RE: Amerada Hess Corp- Former Port Reading Refinery
EPA ID No. NJD045445483
750 Cliff Road
Woodbridge Township, Middlesex County
PI#: 006148

Comment Letter: Conceptual Site Model (CSM) Response to Comments

Comment 9: CSM figures - Portions of Figure 4-1 (below): This area appears to be level except for AST berms. 2017 and 2020 ground surface elevation data were provided for monitor wells.

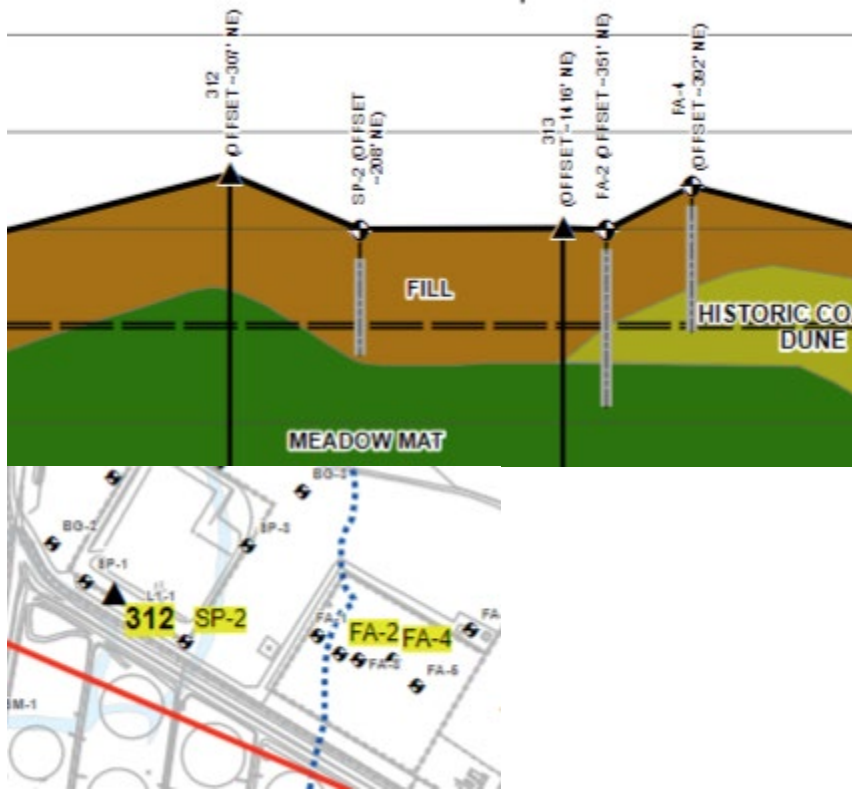
- No ground surface survey data was provided for the other borings.
- Depending on the date of the non-well borings, survey reference points could be different, or there were ground surface modifications. The cross-sections are misleading.

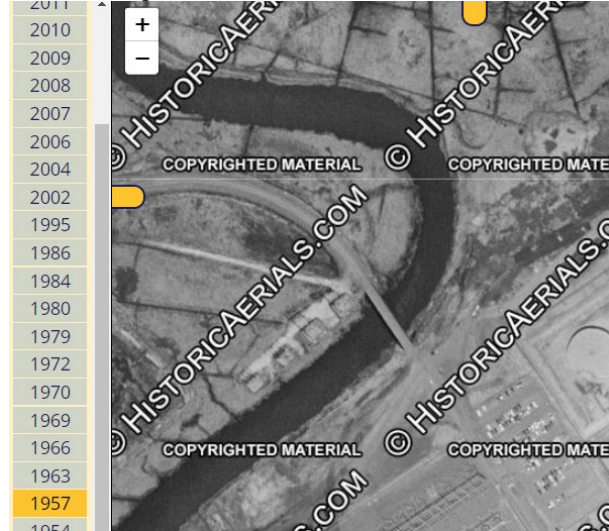
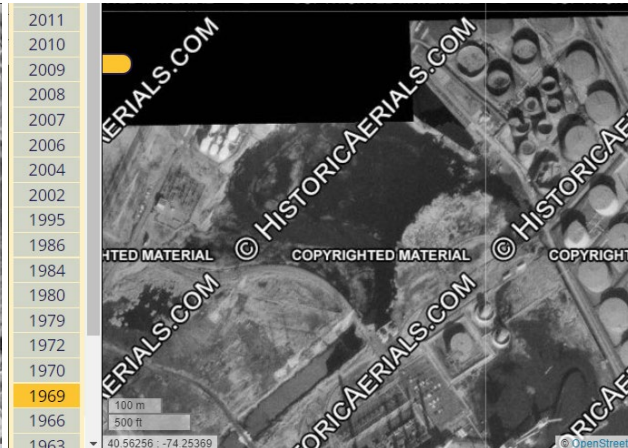
Comment 13: Creation of the Detention Pond area was stated to be between 1966 – 1970. It appears more accurate to state that on-site Smith Creek flow onto the site and at bridges was initially

modified between 1957-1963 and those conditions existed until after the 1969 AST failure. After the 1969 AST failure, and in conjunction with changes in process and storm water management and treatment at the site (as described in the 2015 Aeration Basin RAR), the property line dike constructed between 1970-1972 then contained the facility storm/process waters within the Detention Basin on the property.

1957 – unimpeded flow:

1963: change in flow at bridges and site:

1966: Similar to 1963

1969 after AST Failure:

1970: similar to 1966, some filling of basin occurred:

1972: Dike constructed along property line area: contained facility waters to the site:

Portion of July 2021 Figure 1 Base Map –
AOC Groupings:

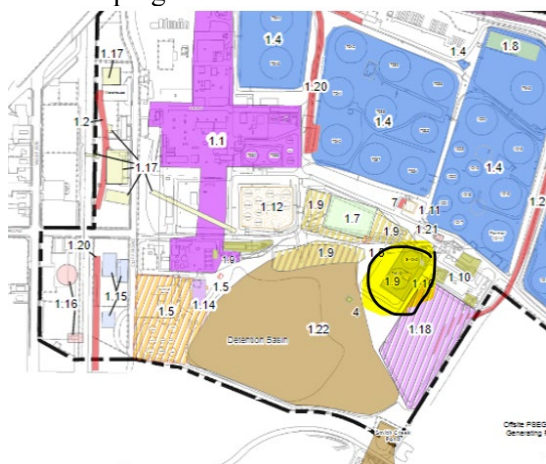
- Historic Sample Location Summary Figure: The response is acceptable. A figure will be included in the CSM. Please ensure the locations of all SIR borings and temporary wells (and investigation locations since the 2015 SIR) are included. For example, only 9 of the 45 soil boring investigation locations in AOC 56 (2RTF Series folder) were included on Figure 44 AOC 56 Soil Analytical Results.
- Backwash lagoon: Correct the location of the backwash lagoon limits.

Location of backwash lagoon with later ASTs and
Aeration Basin limit:
